#### HISTORIC PRESERVATION BOARD

---STAFF REPORT---

December 19, 2017

**Midtown Delray (2017-284):** A Class V site plan application for Midtown Delray that includes 39,396 square feet of retail; 11,117 square feet of restaurant; 55,218 square feet of office; 45 dwelling units; and 39 residential-type inn units. The project also includes the relocation of seven of the existing contributing buildings, reconstruction of one existing building, and demolition of two buildings. The relocation of six of the contributing buildings will occur on Block 61 along Swinton Avenue. Another contributing building will be relocated from Block 61 to the Sundy House property.

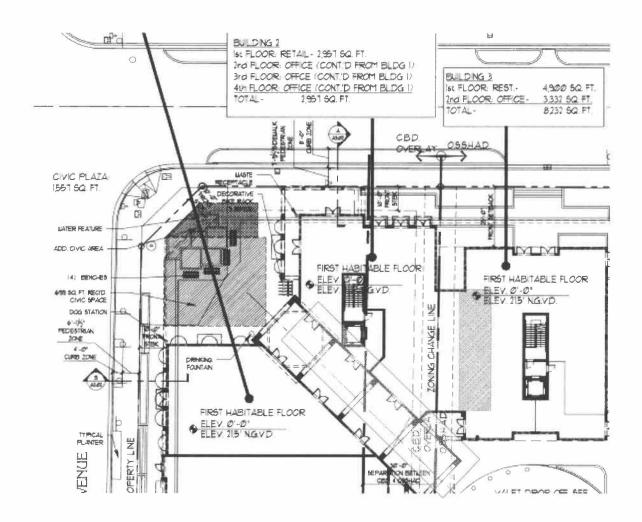
Per LDR Section 4.4.24(F)(4), the maximum width of a building fronting a street shall be limited to 60' and shall have a minimum separation of 15' between buildings fronting a street in a development site that contains more than one structure. The two Residential-type Inn buildings along SW 1st Avenue, the Inn building along Swinton Avenue (building #3), and the Inn building at the southeast corner of Swinton Avenue and SE 1st Street exceed the 60-foot maximum.

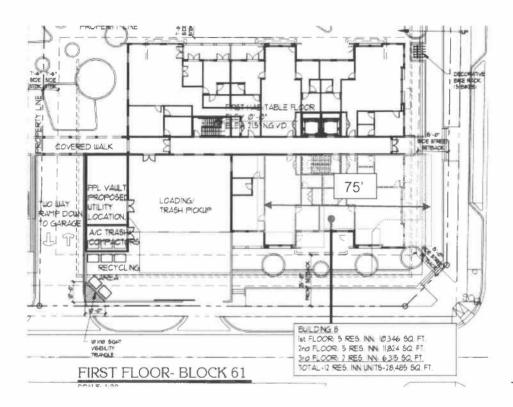
Block 61, Building 8 provides many of the necessary functional aspects of the Midtown Delray Project, which necessitates an additional seventy-six (76) feet in building width along S.W. First Avenue and forty (40) feet along S.W. First Street. Twelve (12) residential inn units comprise Building 8. It also houses a receiving, loading, and air conditioned and acoustically isolated solid waste area that has direct access to SW 1<sup>st</sup> Avenue and whose street frontage consumes fifty (50) feet and three (3) inches. A recycling area consumes an additional twenty-one (21) feet and one (1) inch of street frontage. These project logistics have resulted in a façade that is broken up to reduce the continuous length and relieve the visual length the actual dimension suggests. Similarly, the overhead FPL electric lines that run through the center of the property will be

reworked to underground facilities, which requires an electrical vault that is shown within Building 8 on Sheet A1.02 of the site plan.

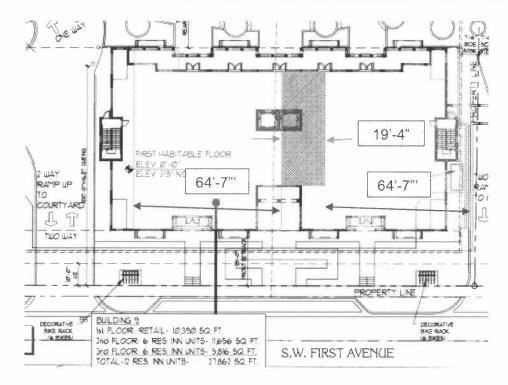
Block 61, Building 9 requires an additional one hundred and four (104) feet in building width in order to provide first floor retail and an additional twelve (12) residential inn units. In order to create a more visual separation in the façade, an additional fifteen (15) foot recess and nearly a twenty (20) foot gap has been added to the middle of Building 9 with landscaping buffers. The main central entry has been eliminated in favor of two entries in the north and south wings. These sixty-five foot wings are connected by the elevator and stairway elements that are stepped back even more on the second and third floors to accommodate upper story planted roofs and a green-wall system. The roof line changes from a sloped roof to a flat roof above the center connection core that further presents the building as two connected facades rather than one long façade.

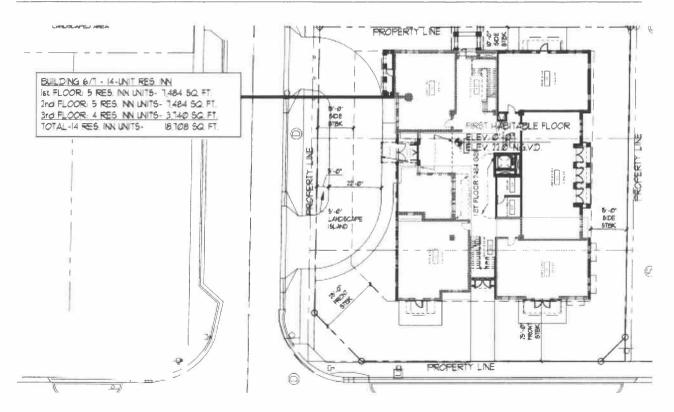
Block 70, Building 6/7 requires an additional forty-four (44) feet and four (4) inches in building width along SE First Street and twenty-one (21) feet and seven (7) inches along South Swinton Avenue in order to accommodate fourteen (14) residential inn units and to integrate the building with the Sundy House. The extension of the overall building beyond the sixty (60) foot façade lengths compensates for the reduction of the permitted three-story building along South Swinton Avenue down to two stories to better transition with the residential along the street and the Sundy House to the west. This is further emphasized with the zoning of the masses separated by the entry facing SE First Street and the stair entry facing South Swinton Avenue.

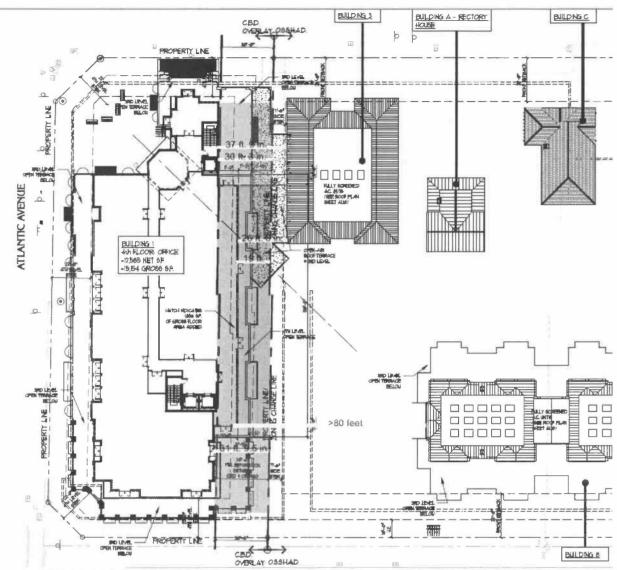
LDR Section 4.6.4(A)(1) is applicable to properties subject to the development standards of the CBD. In this case, Buildings 1 and 2 on Block 61 are subject to the development standards of the CBD and abut an OSSHAD zoned district. LDR Section 4.6.4(A)(1)(a)(ii) requires a minimum thirty (30) foot rear setback if the property abuts a zoning district with a height limitation of thirty-five (35) feet and if the building exceeds three (3) stories in height. Here, Buildings 1 and 2 abut OSSHAD, which limits building heights to thirty-five (35) feet, and Building 1 exceeds three (3) stories in height. Therefore, this code provision requires a thirty (30) foot rear setback for Building 1. Additionally, LDR Section 4.6.4(A)(1)(a)(ii) also provides that the rear setback is measured from the property line to the top of the third story. The Applicant proposes the following: (see illustrations below)

Block	Building	Minimum Rear Setback Required	Proposed Rear Setback
61	1	30 feet	19 feet for a portion of Building 1 from the top of the third floor to the property line only (Approx. 138 feet only)
			The remainder of Building 1 complies with the 30 foot minimum rear setback.
